Havant Borough Council Response – Lighting

Response to comments received from Havant Borough Council on 1st July 2021 regarding lighting, in particular lighting on the proposed footpaths on Hulbert Road for the outline planning application with all matters reserved except access, for the development of up to 120 dwellings and associated improved site access, landscaping, footpaths, SuDS and other associated works. Planning Reference APP/20/00441

Figure 2 – Ecological Receptor Location - South Footpath

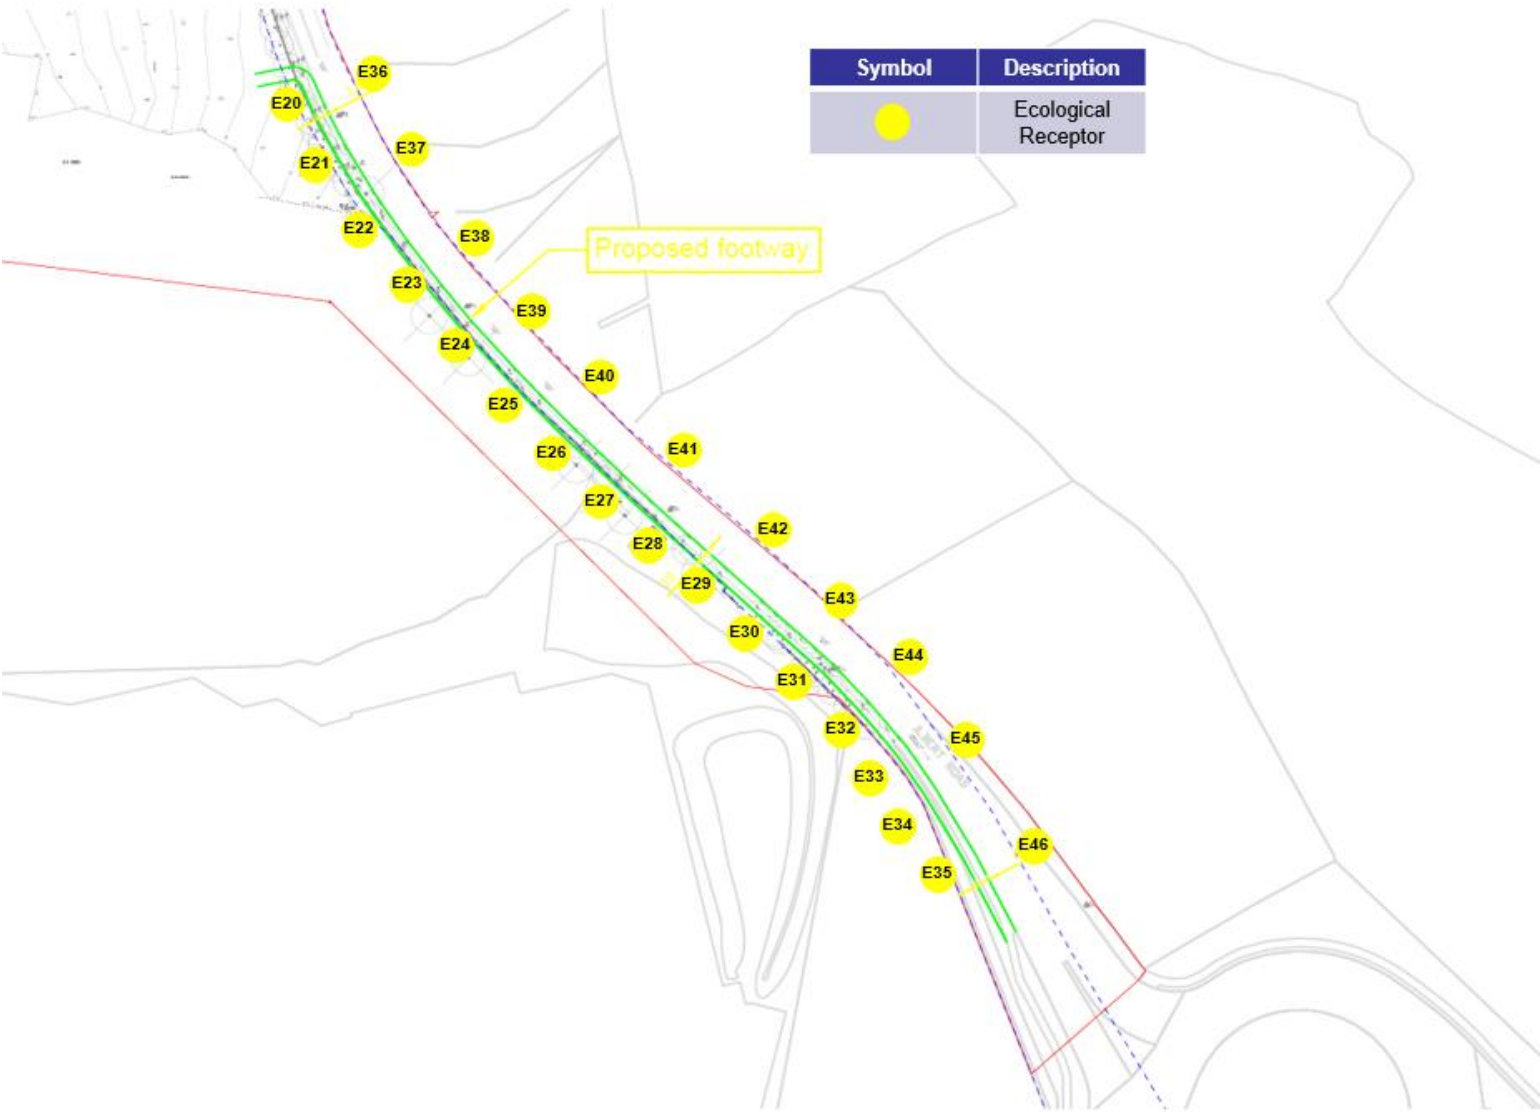
'I spoke to Chris Hirst at the Highway Authority this week who explained in some detail why the street lighting for the footpaths is required at this stage. His concerns were around ecology, levels and the loss of further trees in the future if this is not agreed at the outline stage.'

Following a review of the above documents, the lighting layout for the proposed footpaths north and south of the proposed development along Hulbert Road has been designed to avoid light spill over 1 lux on the trees on both the east and west of the footpath.

Figure 1 illustrates the location of the modelled sensitive ecological receptors for the northern footpath and Figure 2 the southern footpath. Figure 3 illustrates the proposed lighting layout for the northern footpath and Figure 4 the southern footpath.
